UNITED STATES PATENT AND TRADEMARK OFFICE

APPLICATION NO.	FILING DATE	FIRST NAMED INVENTOR	ATTORNEY DOCKET NO.	CONFIRMATION NO.
10/511,855	03/29/2005	Nicola Da Dalt	10808/172	6363

Office Action Summary	Application No.		Applicant(s)	
	10/511,855		DA DALT, NICOLA	
	Examiner		Art Unit	
	Andrew O. Arena		2811

DETAILED ACTION

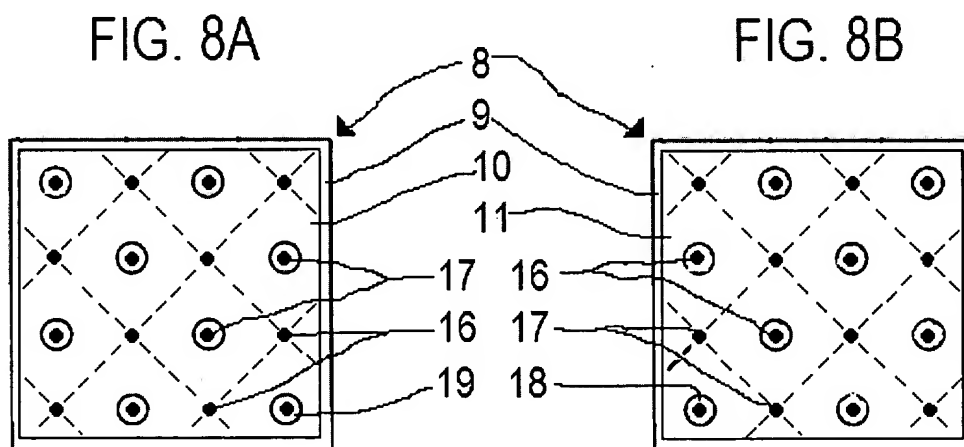
3. Reference is made to the structure of Kuroda Fig 8, which is based on Figs 1-4 (col 8 ln 30-35, col 5 ln 58-59). Fig 8 is analogous to Fig 1, but there are no analogous drawings to Figs 3-4. Examiner has drawn and attached Figs 8A and 8B, which correspond to Figs 3A and 3B, for ease of reference in this rejection. In a similar manner, it is easy to picture the drawing corresponding to Fig 4, which is not shown.

a first substructure (Fig 8A: 10; col 6 ln 9) which has a first cohesive latticed (represented by dashed lines) region which extends in a first common plane (Fig 8A: 10; Fig 4) such that it has common top and bottom surfaces which limit the first cohesive latticed region in each of its subregions (diamond outlined by dashed lines) from above and from below; and

a first substructure having electrically conductive regions (Fig 8A: 17; col 6 ln 62-63) arranged in cutouts (Fig 8A: 19; col 7 ln 21) in the first cohesive latticed region of the first substructure at a distance from edge regions of the cutouts in the common plane, and

wherein the electrically conductive regions comprise node points between via connections (Fig 8A: 17; col 7 ln 21).
